Access Compliance Report

Public Rights-of-Way

(Pedestrian Signals)

Intersection ID: N/A	Main Street:	Cross Street: N/A	Location: N/A
ADA ID: 8DBAC4C97869	Signal Type: One Push Button-Non APS	Overall Compliance: No	Severity Score: BTN 1: N/A BTN 2: N/A No BTN: N/A
Codes/Mitigation Info/Possible Solution		Field Measurements/Component Compliance

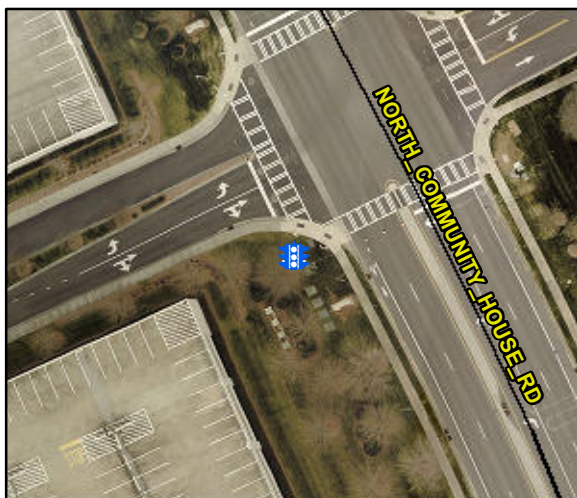
PROW/ADA: TMUTCD 4e.08, R406.2

Compliance	Description	Data	Compliance	Description	Data
	Button Count	Button1	Yes	Distant to Additional Button (in)	197.0
	Additional Button Present?	Yes		Additional Button ID	A4D72D6492DB
N/A	Signal Buttons Required?	N/A	N/A	Additional Ped Posts Required	N/A
	How Many Ped Street Xings?	2		Located In An Island/Median?	No
N/A	B 1 Sign Present?	Yes	N/A	B 2 Sign Present?	N/A
Yes	B 1 Sign Purpose?	Yes	N/A	B 2 Sign Purpose?	N/A
Yes	B 1 Sign Lettering & Contrast?	Yes	N/A	B 2 Sign Lettering & Contrast?	N/A
Yes	B 1 Parallel To XWalk?	Yes	N/A	B 2 Parallel To XWalk?	N/A
Yes	B 1 PAR to Button?	Yes	N/A	B 2 PAR to Button?	N/A
Yes	B 1 PAR to XWalk?	Yes	N/A	B 2 PAR to XWalk?	N/A
Yes	B 1 Clear Floor Space?	Yes	N/A	B 2 Clear Floor Space?	N/A
N/A	B 1 FWD Approach?	Yes	N/A	B 2 FWD Approach?	N/A
N/A	B 1 FWD Approach Constrained?	No	N/A	B 2 FWD Approach Constrained?	N/A
No	B 1 FWD Approach Reach (in)	5.0	N/A	B 2 FWD Approach Reach (in)	N/A

N/A	B 1 FWD Approach Width (in)	N/A	N/A	B 2 FWD Approach Width (in)	N/A
N/A	B 1 FWD Approach Obstruction?	Yes	N/A	B 2 FWD Approach Obstruction?	N/A
N/A	B 1 FWD Approach Obstruction Dist (in)	3.0	N/A	B 2 FWD Approach ObstructionDist (in)	N/A
N/A	B 1 PARA Approach?	Yes	N/A	B 2 PARA Approach?	N/A
N/A	B 1 PARA Approach Constrained?	No	N/A	B 2 PARA Approach Constrained?	N/A
Yes	B 1 PARA Approach Reach (in)	5.0	N/A	B 2 PARA Approach Reach (in)	N/A
N/A	B 1 PARA Approach Width (in)	N/A	N/A	B 2 PARA Approach Width (in)	N/A
N/A	B 1 PARA Approach Obstruction?	Yes	N/A	B 2 PARA Approach Obstruction?	N/A
N/A	B 1 PARA Approach Obstruction Dist (in)	3.0	N/A	B 2 PARA Approach ObstructionDist (in)	N/A
Yes	B 1 Clear Floor Space Slope (%)	3.3	N/A	B 2 Clear Floor Space Slope (%)	N/A
Yes	B 1 Clear Floor Space XSlope (%)	1.6	N/A	B 2 Clear Floor Space XSlope (%)	N/A
N/A	B 1 PAR Slope (%)	4.2	N/A	B 2 PAR Slope (%)	N/A
Yes	B 1 Height (in)	42.0	N/A	B 2 Height (in)	N/A

Yes	B 1 Clear Xing Direction?	ClearlyMarked	N/A	B 2 Clear Xing Direction?	N/A
	B 1 Crossing Direction	To NW		B 2 Crossing Direction	N/A
Yes	B 1 DistanceTo XWalk (in)	0.0	N/A	B 2 DistanceTo XWalk (in)	N/A
No	B 1 DistanceTo Curb (in)	82.0	N/A	B 2 DistanceTo Curb (in)	N/A
Yes	B 1 Diameter (in)	2.0	N/A	B 2 Diameter (in)	N/A

Possible Solutions: Replace Signal Push Button With APS Button on New Post. Remove & Relocate Sign.
